REBUTTAL STATEMENT

**IN RELEATION TO ONGOING PLANNING APPEAL REF:
APP/H6955/A/21/3281507**

LAND AT QUARRY BROW, GRESFORD, WREXHAM, LL128SG

Land at Quarry Brow, Gresford – Highways Technical Note 01

DRAWING TITLE: Existing Visibility & Proposed Site Swept Path Analysis

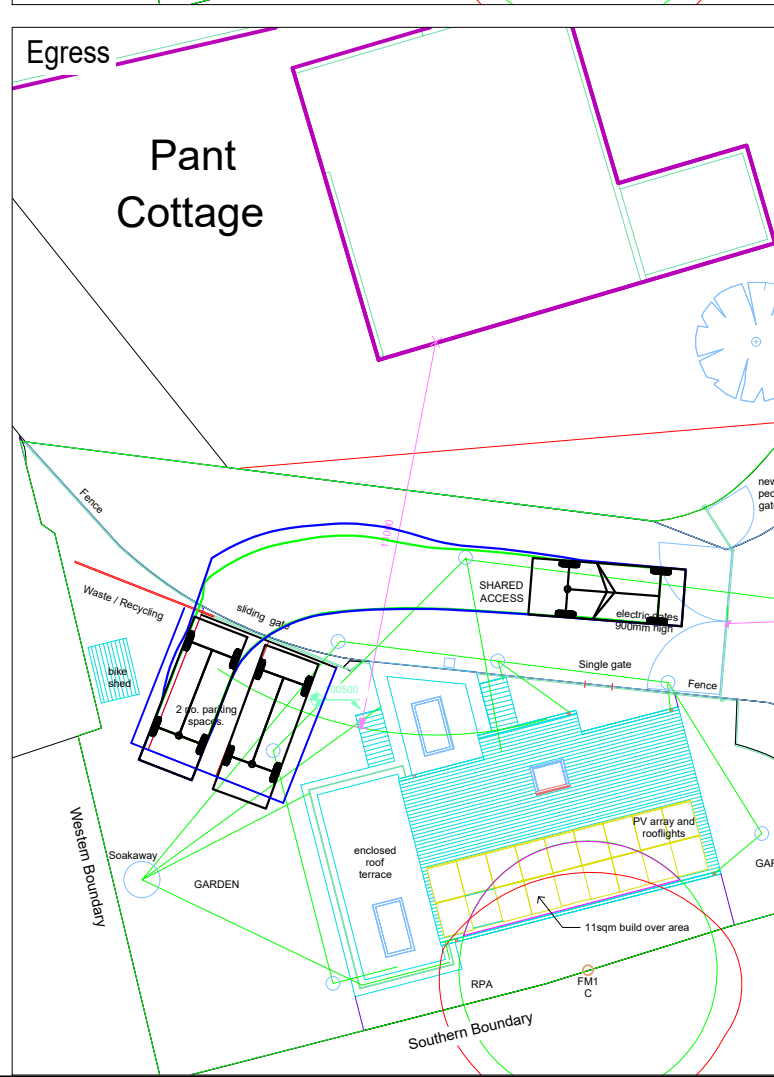
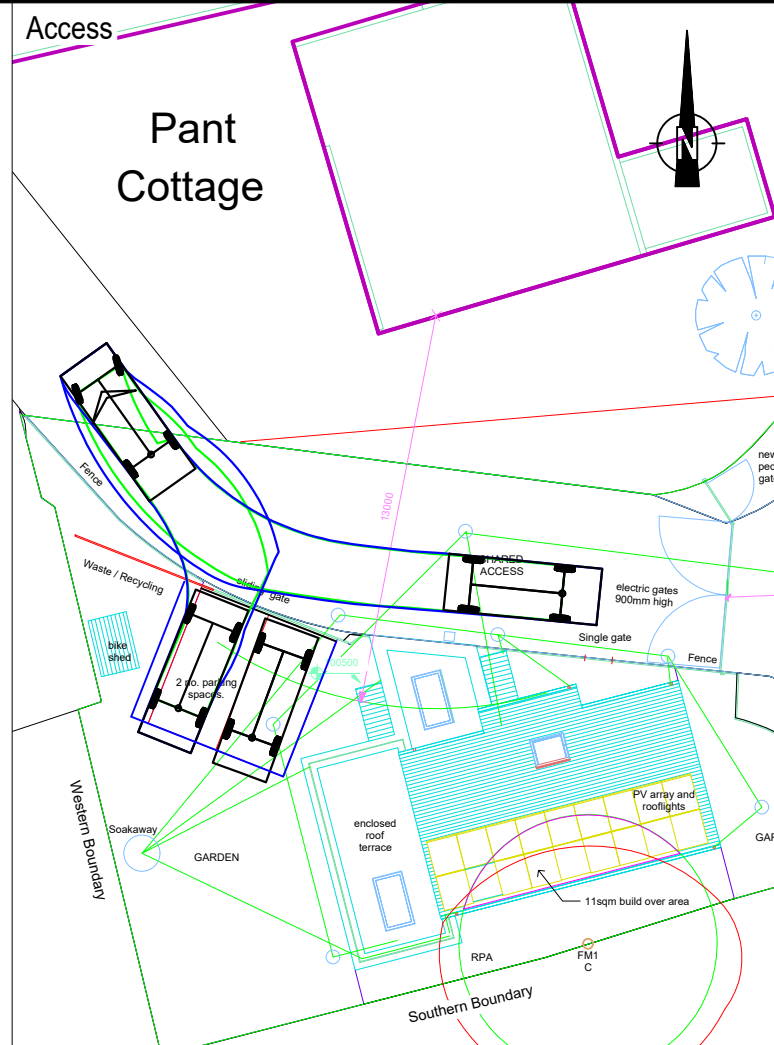
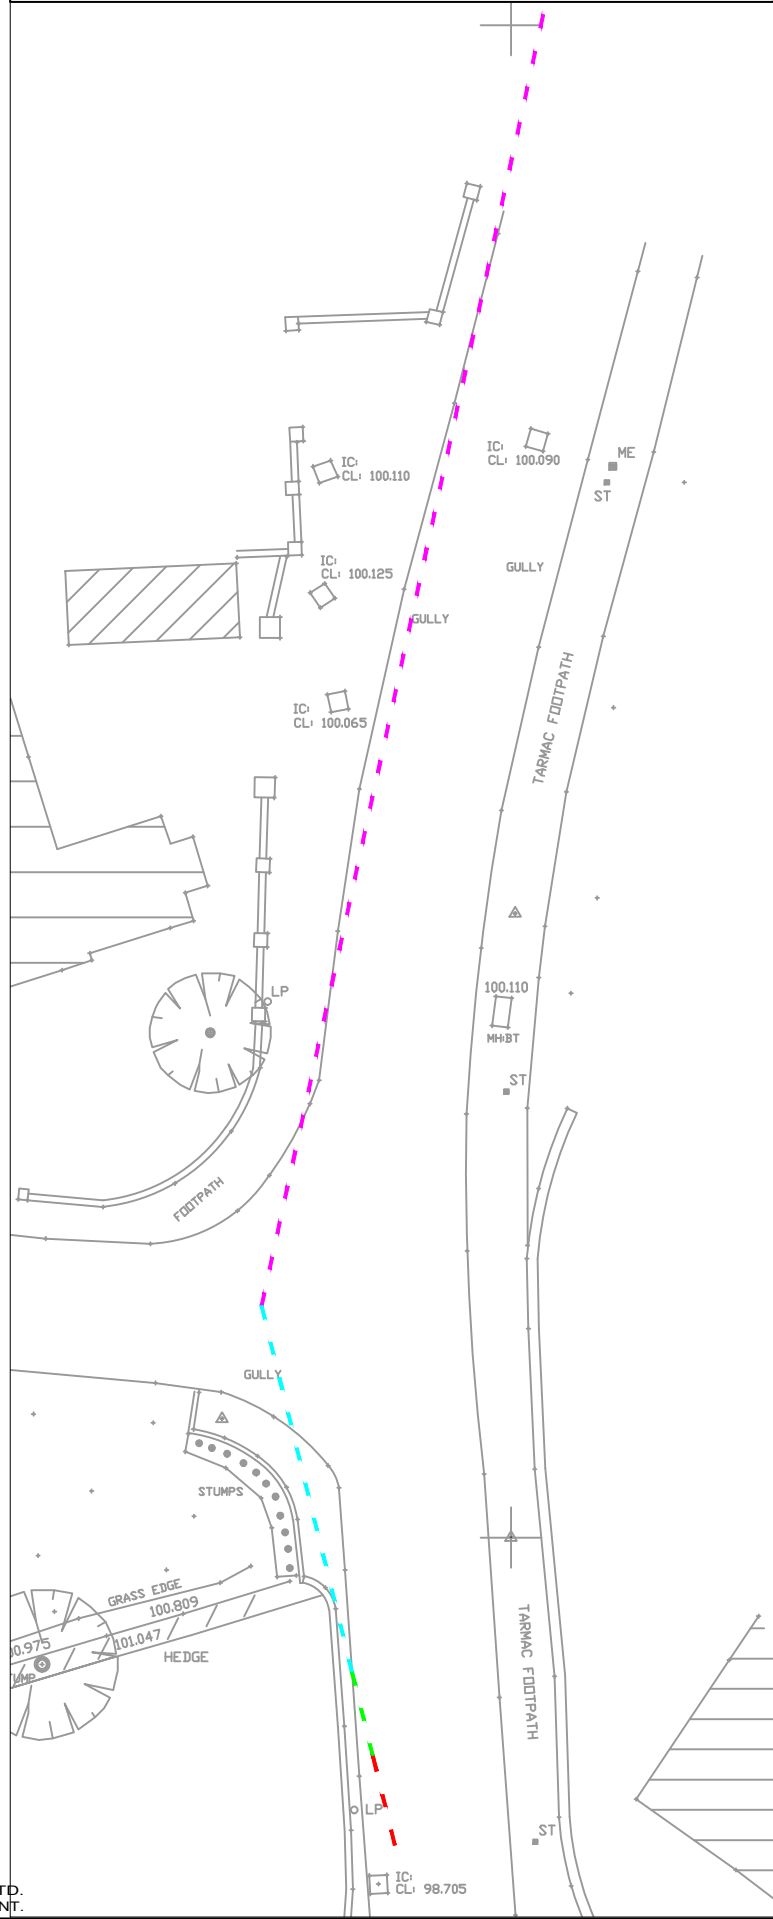
4. In reviewing proposals for the proposed new dwelling, WCBC Highways commented on the visibility at the existing access junction on Quarry Brow, parking provision within the site and arrangements to accommodate a medium-sized delivery vehicle. This note considers each of the three items commented on by WCBC Highways, with the intention of providing additional information to assist with the overall determination of the appeal (if required).

6. In providing their comments, WCBC Highways have acknowledged the fact that the existing access junction is located approximately 30 metres north of the Quarry Brow/Pant Lane junction and as such, vehicle speeds are likely to be lower than the signed 30mph limit (i.e. suggested typical speeds of 20mph travelling southbound and 15mph travelling northbound).

13. WCBC Highways acknowledge that the provision of two parking spaces proposed for the new dwelling would be adequate. However, access into and out of these spaces has been queried.
14. The layout as presented includes two marked car parking spaces set behind a sliding gate. These parking spaces appear to be in the rough location of an area currently used for parking. Although marked on the layout as two formal parking spaces (approximately 2.4 metres by 4.8 metres) it is considered that there would be additional width available and therefore additional flexibility within the curtilage to accommodate the parking of vehicles in this location. As part of this, it is considered that there is also flexibility regarding the overall width of the sliding gate which would provide access to the parking area.

17. It has been suggested by WCBC Highways that a communal turning area should be provided as part of the development proposals in order to facilitate the turning movements of a medium-sized service vehicle. It is assumed that this relates to a 4.6 tonne light goods vehicle or 7.5 tonne panel van for the purpose of online food deliveries and/or online mail order services which have the potential to occur on a regular basis, albeit typically outside of peak times.

9. A review of visibility from the existing access junction has been conducted and is presented in **Plan 1**. Initially, visibility from a 2.4 metres setback has been considered. Visibility to the north of the access can achieve approximately 43 metres which is in excess of the TAN 18 requirement for a suggested 20mph typical speed. To the south, visibility is restricted by a boundary wall to approximately 12 metres when measured to the nearside kerb edge. This assessment broadly aligns with the review provided by WCBC Highways.

10. It is acknowledged that although visibility splays should generally be drawn to the nearside kerb edge, practical sightlines achievable to the path of an approaching vehicle can also be considered. With this in mind, the practical sightlines achievable from a 2.4 metres setback would be approximately 14.5 metres using a kerb offset of 0.5 metres, and approximately 17 metres using a 1 metre kerb offset. These are often referenced as being suitable for vehicle speeds of approximately 12mph and 14mph respectively, accounting for bonnet adjustments.

11. In addition, at lightly trafficked junctions in slow speed situations, sightlines measured from a 2 metres setback can be considered, as noted in TAN 18. **Plan 1** also presents sightlines measured from a 2 metres setback to the nearside kerb at approximately 12.5 metres. Using a kerb offset of 0.5 metres, a sightline of approximately 15.5 metres is achievable whilst using a kerb offset of 1 metre, a sightline of approximately 18.5 metres is achievable. These are often referenced as being suitable for vehicle speeds of approximately 13mph and 15mph respectively, accounting for bonnet adjustments.

15. To assist in providing additional information, **Plan 1** presents an initial vehicle tracking exercise for the area identified for parking within the site. Although it is possible to drive into the parking area, the vehicle tracking shows a more likely scenario whereby vehicles reverse into the parking area so as to be able to drive forwards out through the gates. This is not considered to be unreasonable and demonstrates what can be achieved practically.

16. Regarding the vehicle tracking, it is possible to access the spaces in and out without having to affect the existing footway and kerb upstand on the northern side of the existing carriageway. This is due to the existing carriageway alignment which facilitates manoeuvres into and out of the parking area and although the proposals include for the provision of an improved shared space in this area, it could be considered desirable but not necessary when considered in relation parking manoeuvres.

18. It is noted that electric gates are proposed approximately 5 metres back from the access junction with Quarry Brow. Although these may be desirable, they are not considered necessary and could be omitted from the scheme. The removal of these electric gates would allow a medium-sized service vehicle to position itself on Quarry Brow immediately north of the access junction and then reverse into the private drive with minimal conflict.
